June 27, 2023

Subject: Northwestern University Ryan Field  
Environmental Assessment Review and Summary

Figure 1: Time History of LeqA Values during Game Day Activities (October 7-10, 2022)

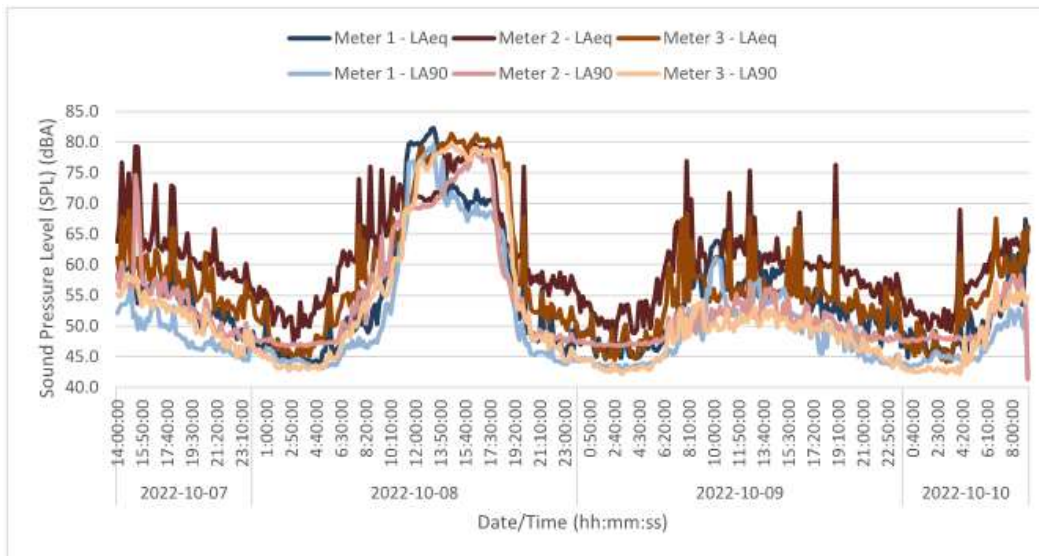
A review of the measured sound data during the game day weekend at the existing stadium shows an increase in sound levels on Saturday, October 8, during the time the football game and associated activities would occur. By reviewing the graph, it is showing sound levels begin increasing rapidly around 9-10 am and continue through game time before subsiding around 6pm. The levels on Saturday are higher than the Sunday, October 9, sound levels and are indicative of the sound generated at the stadium compared to typical ambient sound. Further, the sound measurements taken during a non-game day weekend confirm the typical ambient sound levels in the area are consistently lower than the measured pre-game/game activity at the existing stadium. It is shown in these figures that the current

weekend daytime ambient sound levels are around 60-65 dBA, and that game day activities increase these sound levels up to 70-80 dBA, notably for a period of time that extends beyond just the football game itself.

It should be noted the sound monitoring positions during game day measurements were located on the Ryan Field/Northwestern University property and were identified as tailgating activities, music in the parking lot(s), and large crowds. As the measurement locations are essentially “within” the sound source, these are considered the highest sound levels in the area. Sound level will diminish at some rate as it moves into the residential communities meaning the actual stadium sound impact may be less in the neighborhoods as compared to what was measured in the parking lots.

Figure 3: Concert Environmental Assessment Results (dBA)

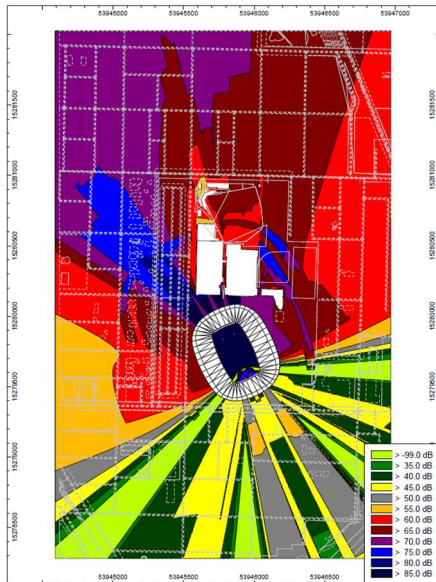
The results of this analysis show sound generated at the new stadium is projected to the north and west. Areas to the east and south also show sound impact, but less so than to the north. Sound transmission to the south could be described as noticeable but generally does not substantially exceed the ambient sound levels measured in the area. Alternative stage locations do not appear to be an attractive option for sound mitigation, given the sound reduction benefits of the building barrier effect related to Welsh-Ryan Arena and other existing Northwestern structures. That is, the existing structures

help block/shield transmission to the north residential properties; there is no such barrier at the south of the property to provide the same barrier effect to those southern residences.

Predicted sound levels are approximately 55-75 dBA and 85-95 dBC; dBA levels will reach similar peak levels to those measured for game day activities at the existing stadium. Levels associated with concerts, while elevated, are expected to occur for shorter aggregate periods of time than football game day activities, though they may be more consistent during that period. We estimate the typical concert to be approximately 3-4 hours (doors open to end of encore), less than the 6-8 hours observed for game day events.

Projected concert sound levels were evaluated at the surrounding property lines. The Henderson model accounts for disruption to sound patterns caused by University-owned structures (such as impact seen in the graphic above), but does not account for the impact of non-University owned property. Therefore, the model doesn't account for the impact of residential buildings or other structures, which would limit how far into the residential area sound travels before it reaches ambient levels. The sound levels in the residential community will be lower than at the property line, when factoring in the impact of other structures, distance, directivity, and other factors.

The Henderson model results shown above does not account for any additional sound mitigation efforts beyond the two design features noted above.

Figure 5: Concert Environmental Assessment Results with Additional Sound Mitigation (dBA)

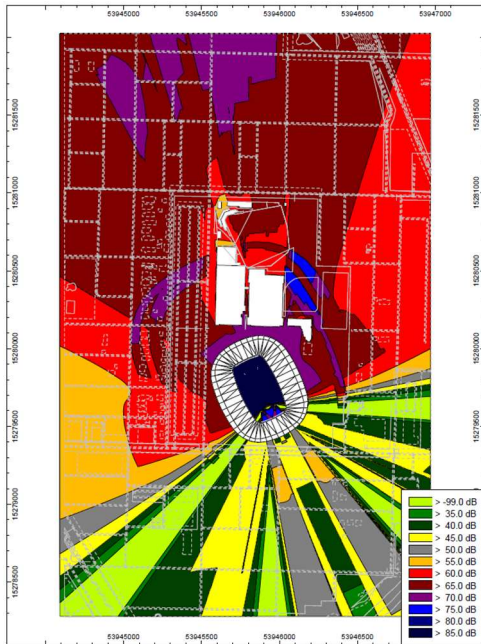
With additional effective mitigations, there is a noticeable reduction in sound impact on the immediate West property line, and a noticeable reduction in sound impact to the Northwest. While sound will still be audible, projections generally fall in the 60 and 65 dBA ranges. There is a small sound shadow impact to the north that would positively impact a small number of residents. Again, this model does not account for the beneficial sound reduction impact that would be generated by the residential houses at the property lines.

Additional modeling is required to determine the exact extent of the barriers and the necessary sound reduction qualities of the materials installed, but our recommendation is that Northwestern consider including this mitigation in the project, or have the opportunity to add them at a later time as an additional mechanism to mitigate environmental sound transmission.
